APPENDIX: PUBLIC COMMENT RECORD

PUBLIC COMMENTS AND RESPONSES RECIEVED DURING PUBLIC COMMENT PERIOD (JANUARY 24 - MARCH 9, 2022) FOR THE REGIONAL MOBILITY STRATEGY (RMS) 2050 METROPOLITAN TRANSPORTATION PLAN (MTP), RMS 2023-2026 TRANSPORTATION IMPROVEMENT PLAN (TIP), AND TRANSPORTATION CONFORMITY REPORT (TCR)

Figure 3: Trip Length Distribution for Trips Entering and Exiting I-10 Segment 2 During the Afternoon Peak Period (2:30 – 6:30 p.m.) calculated from the 2017 base year model

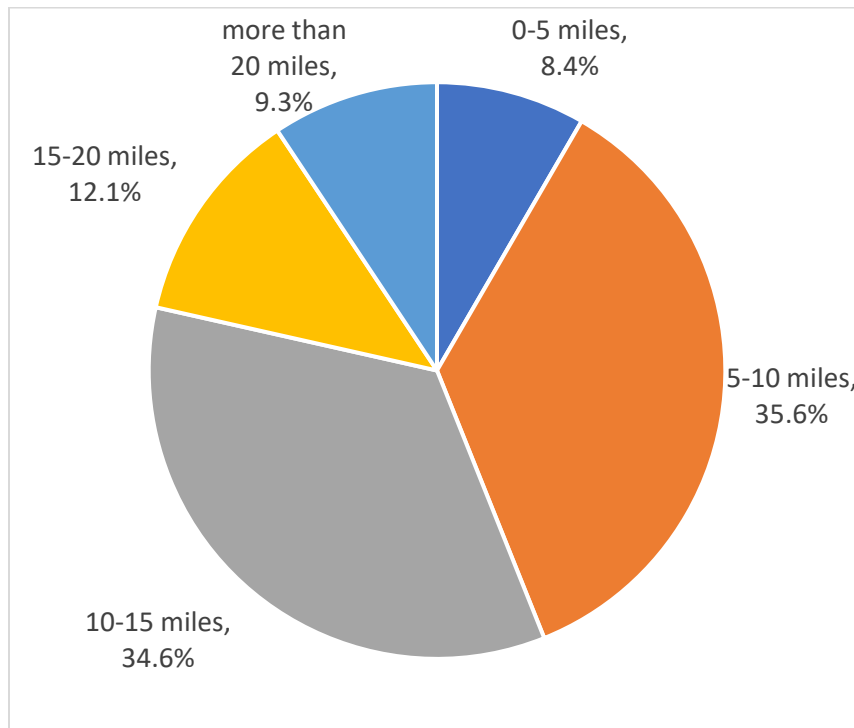
As shown in Figure 3, almost half of the trips are less than 10 miles in length. Less than 10% have length exceeding 20 miles.

Figure 3 shows the distribution from 26 ramps. Some of the ramps have a much higher proportion of very short trips. For example, 29% of the modeled trips entering I-10 westbound west of Copia Street are less than 5 miles in length, i.e. mostly traveling to the Downtown.

Many of these short trips are traveling out of their way to save a minute or two. If short trips could be removed from I-10, I-10 would be uncongested, even in peak traffic periods.

Figure 5: Afternoon Peak Period Eastbound Piedras to Copia Modeled Traffic Classification

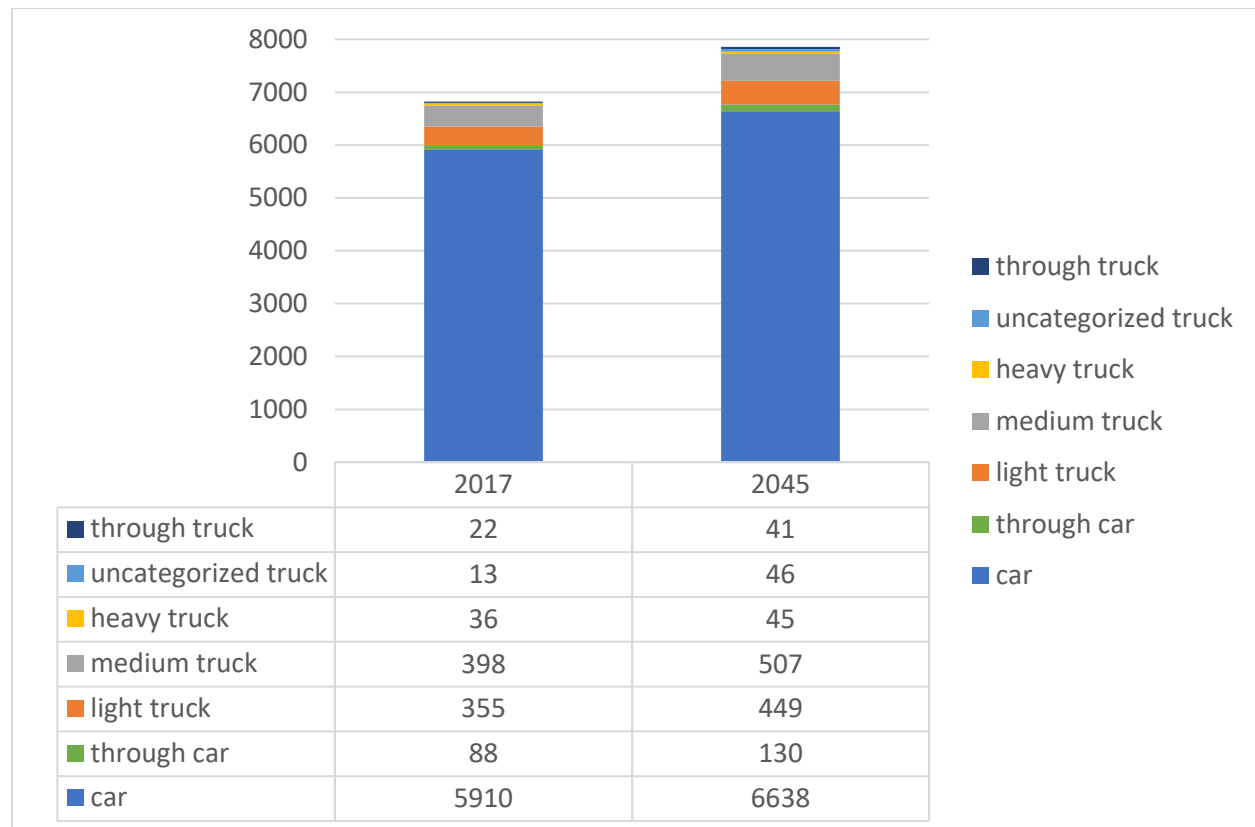
Figure 5 shows the modeled distribution of afternoon peak period traffic eastbound between Piedras and Copia. While the model shows a doubling of through trucks between 2017 and 2045, the 2045 number is still less than 1% of total traffic. Local heavy trucks are also less than 1% of total traffic. Cars and light trucks are 92% of total traffic in 2017 and 90% of total traffic in 2045.

Figure 7: 2019 Afternoon Peak Period (2:30 – 6:30 p.m.) Speed vs. 2017 Base Year Model from 24/7 speed data provided by TxDOT

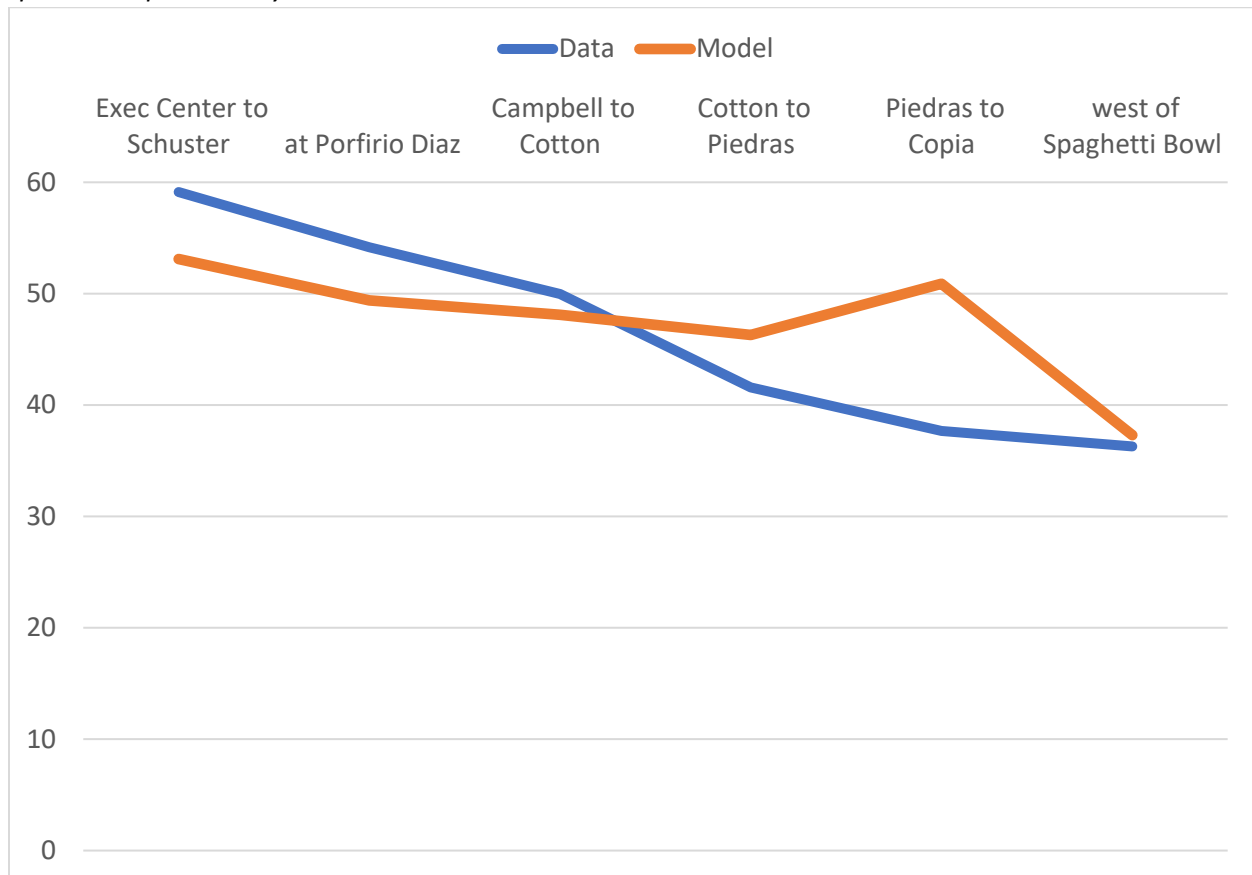
The model fails to match the actual speed data in the afternoon peak period as shown in Figure 7.

The model treats every segment as independent. Although the model correctly identifies the Spaghetti Bowl as the lowest-speed section, it fails to account for how this bottleneck affects upstream traffic flow and therefore overestimates the speed between Piedras and Copia. It also underestimates speeds that are less affected by bottlenecks including the west half of Segment 2.

Figure 8: Piedras to Copia Eastbound 2019 Speed (24/7 data provided by TxDOT) vs. 2017 Base Year Model

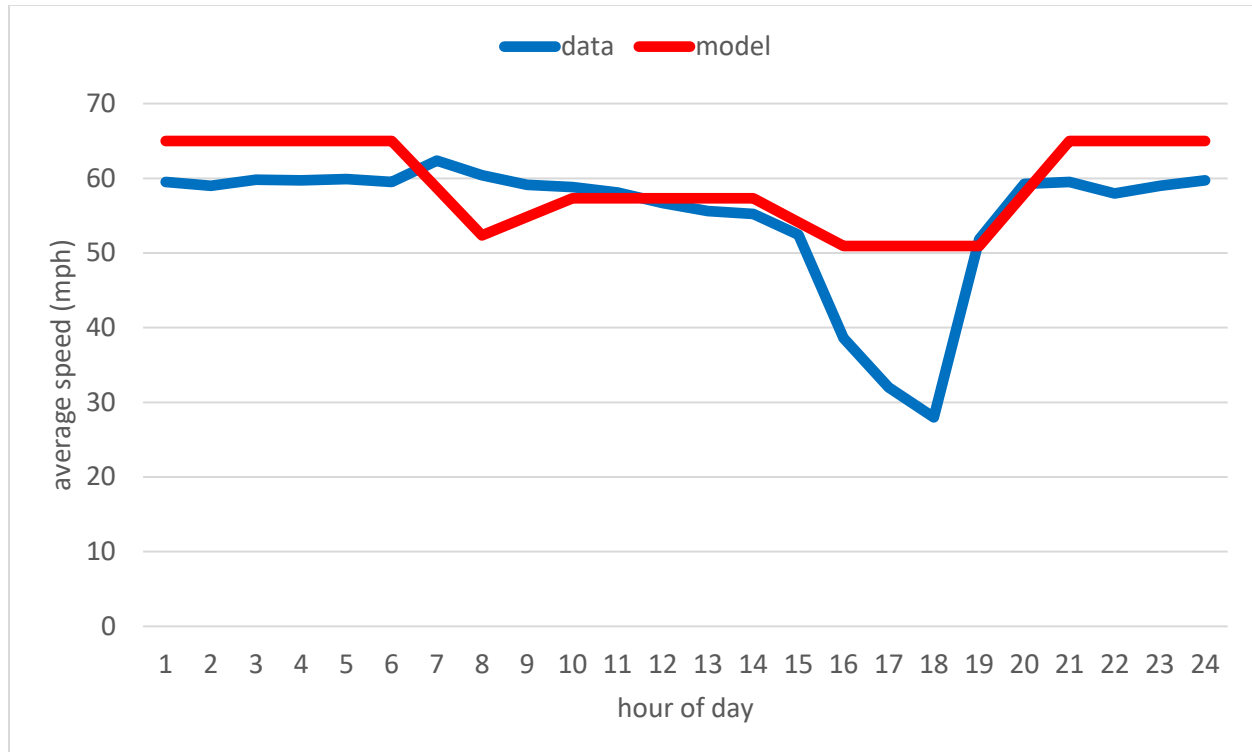
Model speeds match data even more poorly across the 24-hour day as illustrated in Figure 8 for the I-10 eastbound between Piedras and Copia.

Model errors shown in Figure 8 include:

The actual uncongested average speed taken from the overnight period is 60 mph as illustrated in Figure 8. Using 60 mph rather than the 65-mph value assumed in the model and MTP delay calculations, there is little delay outside the PM peak period. Figure 9 compares delay based on actual speeds vs. delay as calculated in the model. The model incorrectly indicates that over half of the delay is outside the afternoon peak period, while greatly underestimating the afternoon peak period.

Figure 9: Afternoon Peak Period Delay Eastbound Piedras to Copia – Data (relative to 60 mph speed) vs. Model (relative to 65 mph speed), both multiplied by traffic volume

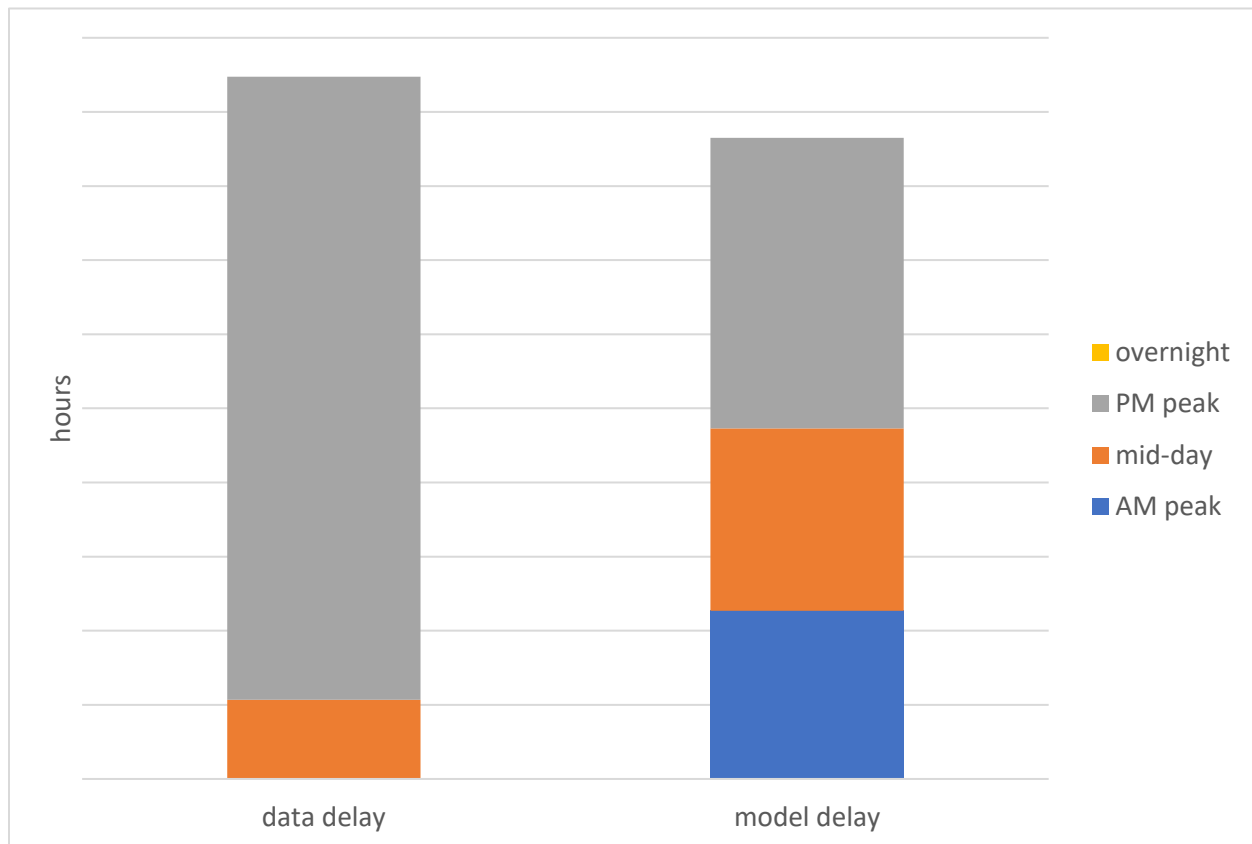
These delay calculation errors are caused by incorrectly treating successive road segments as independent. This modeling method, static traffic assignment or STA, was adopted 40 years ago when computers were less powerful than today's smart phones. In peak periods, traffic congestion is characterized by queues behind bottlenecks. In STA there are no queues behind bottlenecks. As documented above, this leads to the model predicting delay in the wrong places at the wrong times.

Figure 13: TxDOT Adaptive Lane Illustration

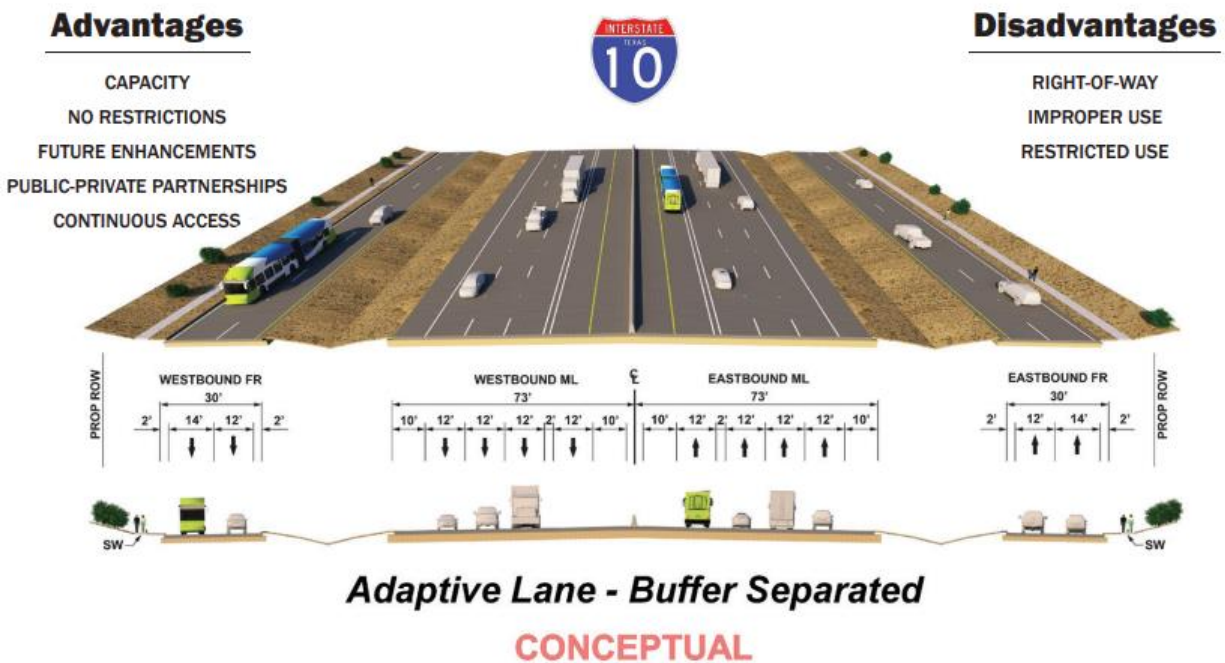
The attributes of these “transit-adaptive” lanes are not described in the MTP. Figure 13 reproduces a TxDOT graphic showing adaptive lanes.

The 2045 model includes only 5 bus routes that use I-10. This represents fewer than 10 buses per hour on any segment of I-10. Figure 13 shows only a single bus in the adaptive lanes but constructing these lanes cannot be justified solely for transit.

Figure 14: Alternative H showing median U-turn lanes

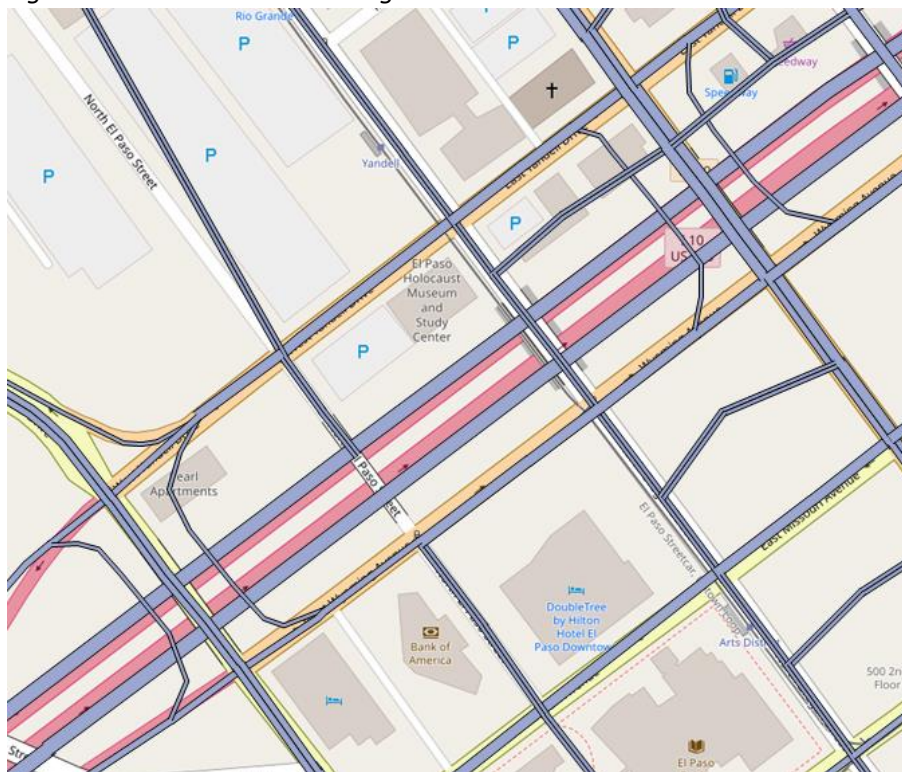
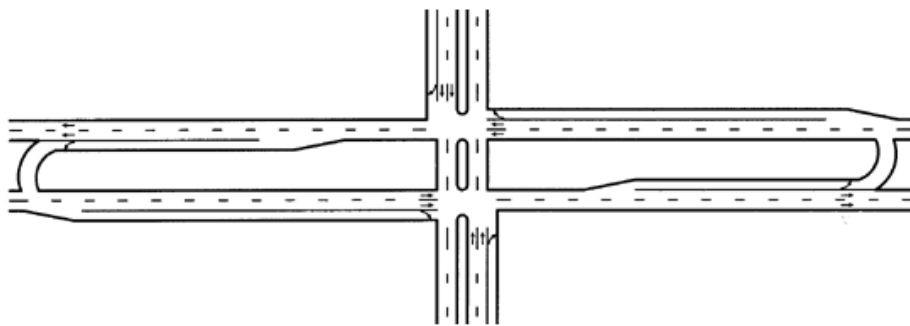
An Alternative H shapefile⁹ provided by TxDOT show continuous frontage roads including the conversion of portions of Yandell Drive and Wyoming Avenue to frontage roads downtown. In Alternative H, a central feature of these downtown frontage roads is median U-turn lanes (Figures 14 and 15).

These median U-turns will require a lot of property taking and likely are unnecessary. I recommend that these lanes be removed unless their value is clearly demonstrated.

The best aspect of the version of the downtown “frontage roads” illustrated in Figure 14 is that it does not include this problem of too many ramps in a short space. Instead, the frontage roads operate as a collector-distributor system where local traffic exits the freeway at one end and then reconnects some distance beyond.

Figure 16: Afternoon Peak Period (2:30 – 6:30 p.m.) Modeled Traffic Volume Piedras to Colia

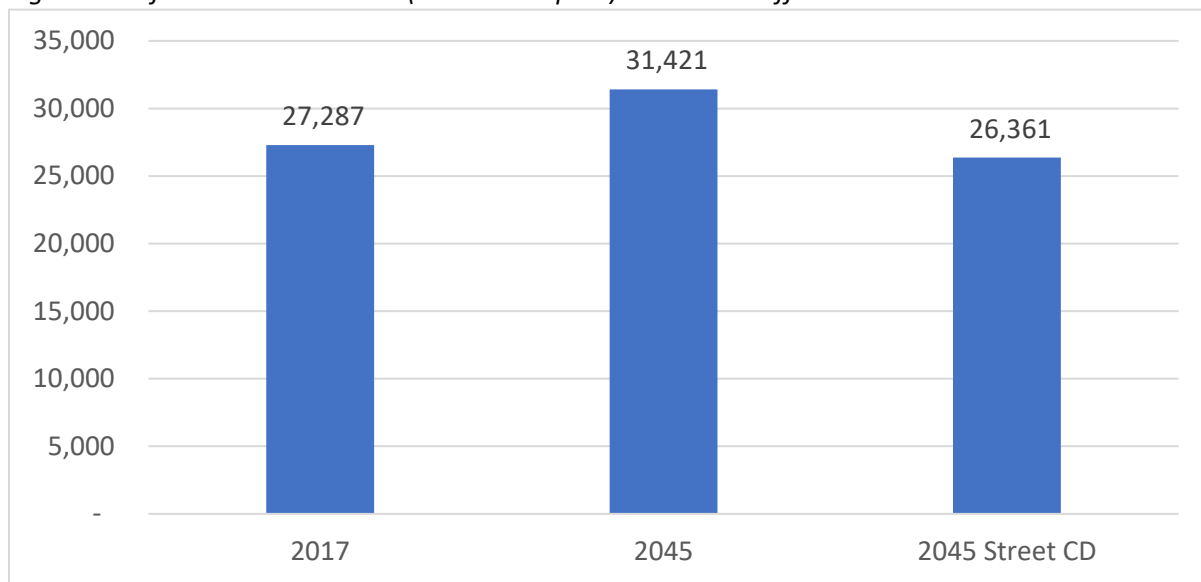
Figure 16 is based on the differences between the 2045 amended MTP model and a 2045 Street CD alternative model. The segments colored green (including I-10) have modeled traffic volumes that are lower by 1000 vehicles or more across the 4-hour afternoon peak period (2:30 – 6:30 p.m.) Traffic also would be lower on Cotton Street, Piedras Street and Copia Street in the vicinity of I-10 which could relieve congestion in these areas. The links that are colored red have traffic volumes that are higher than 1000 vehicles or more across the 4-hour period. As shown in the figure, the diverted traffic is spread across multiple east-west streets. These streets appear to have adequate capacity, and additional traffic would help some businesses along these streets. Interestingly, the traffic volumes along the eastbound and westbound collector-distributor streets (i.e., Gateway Boulevard) are not particularly high because other parallel streets offer more direct routes for many local trips.

In the final phase of this project, I will refine this alternative and do a more complete evaluation. I will consider the need for adding general purpose lanes and I also will look at extending the street collector-distributor concept to the west of downtown.
